Service Bulletin

SUBJECT: Service Update for Inventory and Customer Vehicles
Product Enhancements – Interior Trim
Expires with Base Warranty

MODELS: 2013 Cadillac XTS

Date: March 18, 2013
Subject: 12250A - Service Update
Product Enhancements - Interior Trim
Revised Part Information and Service Procedure Sections
Models: 2013 Cadillac XTS
To: All Cadillac Dealers
Attention: General Manager, Service Advisor, Service Manager, Parts and
Service Director, Parts Manager, New Vehicle Sales Manager, and
Warranty Administrator

2755689

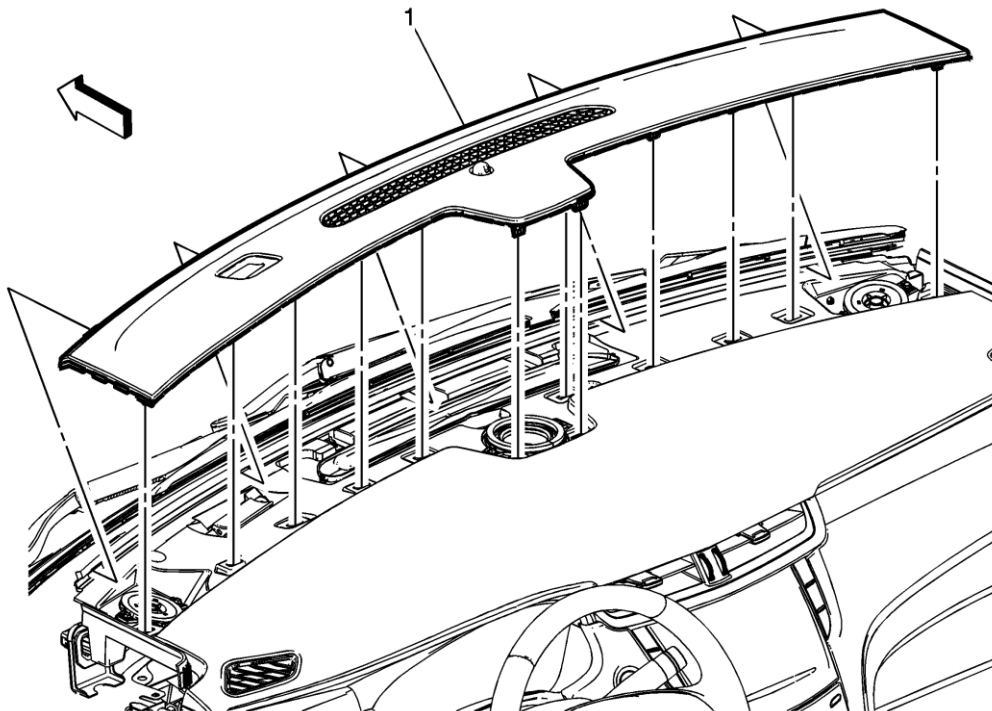
1. Remove the driver and passenger seat outer track front covers (1). Refer to *Front Seat Track Cover Replacement* in SI.
2. Install new driver and passenger seat outer track front covers (1). Refer to *Front Seat Track Cover Replacement* in SI.

2759601

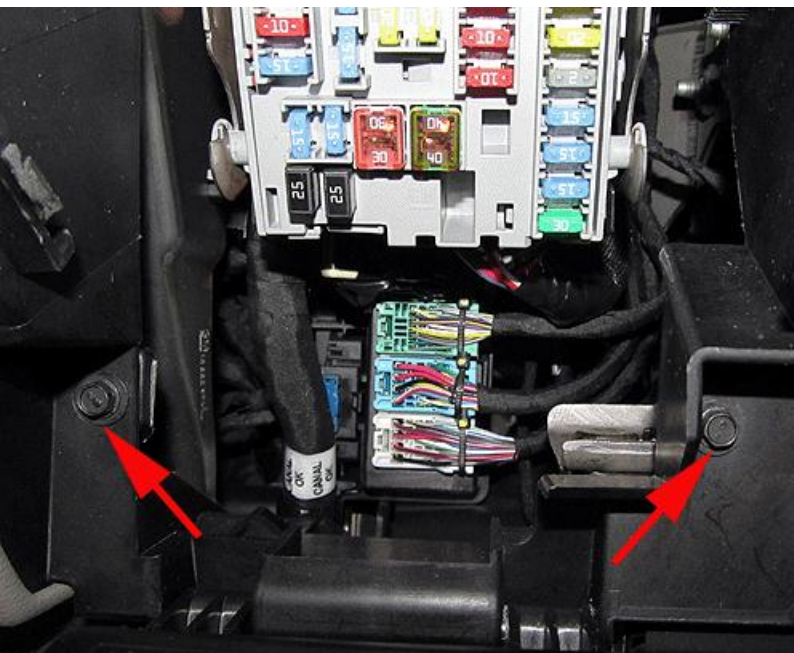
Note: Contrary to what the replacement procedure in SI states, the windshield garnish moldings do not require removal.

5. Remove the windshield defroster grille. Use a flat bladed plastic trim tool to release the 12 retainers to prevent damage to the instrument panel upper trim panel.
6. Place the windshield defroster grille on a clean level surface with the backside facing up.
7. Using Kent Automotive BRS (Felt) Tape, P/N KT13486 or Sheet, KT13487, cut five 15 mm x 60 mm strips.

3258653

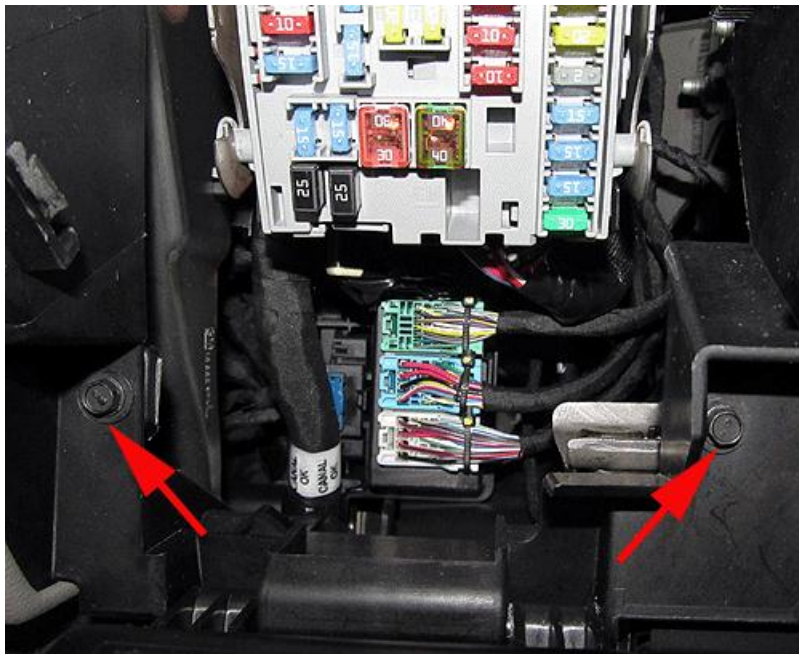
IP Storage Compartment Door Binds or Opens Very Slowly

Note: This procedure should move the rack upward slightly to release excessive engagement of rack and pinion gears.

1. Open bin door with release tabs.
2. Loosen two screws.

3. While pulling downward on left side, tighten the left screw first and then tighten the right screw.

Note: If the bin door is still slow, then repeat steps 2-3, but add an upward push at the bottom right side BEFORE tightening the right screw. Replace the IP storage compartment if the adjustment does not correct the condition. Refer to *Instrument Panel Knee Bolster Replacement* in SI.

3258653

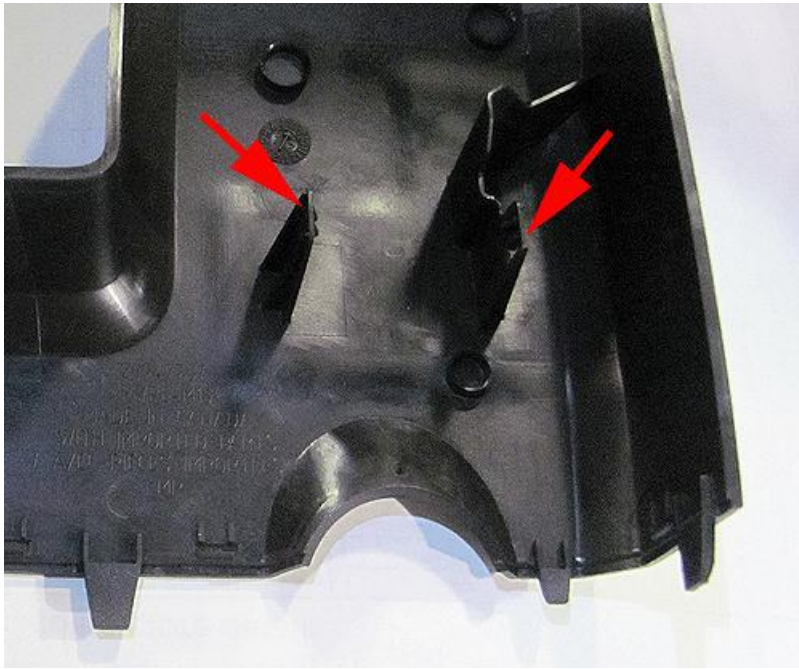
IP Storage Compartment Door Opens Very Fast and/or Creates Zip Noise

Note: This procedure should move the rack downward slightly to create more engagement of the rack and pinion gears.

1. Open bin door with release tabs.
2. Ensure pinion gear is seated.
3. Loosen two screws.
4. While pulling downward on the right side, tighten the right screw first and then the left screw.

Note: Replace the IP storage compartment if the adjustment does not correct the condition. Refer to *Instrument Panel Knee Bolster Replacement* in SI.

3258663

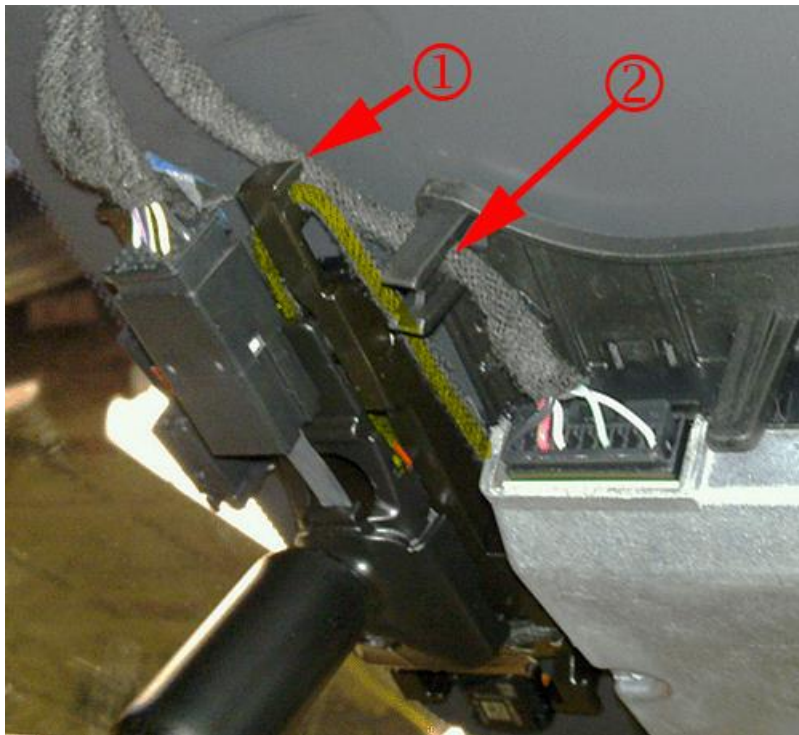
15. Locate the windshield multifunction sensor mount bracket cover. The inside rearview mirror arm protrudes through the center of the windshield multifunction sensor mount bracket cover.
16. Gently rock the windshield multifunction sensor mount bracket cover in a cross-car direction. The cover should feel solid and not separate into two halves or fall off the windshield.
 - If the windshield multifunction sensor mount bracket cover does not separate into two halves or fall off the windshield, no further action is required.
 - If the windshield multifunction sensor mount bracket cover does separate into two halves or falls off the windshield, proceed to step 17.

17. Remove the windshield multifunction sensor mount bracket cover and inspect the molded-in plastic clips located on the inside of the cover. Ensure the plastic clips are not bent or damaged. Straighten the bent clips and reinstall the windshield multifunction sensor mount bracket cover. Proceed to step 18. If the plastic clips are broken or badly damaged, replace the windshield multifunction sensor mount bracket cover. Proceed to step 18.
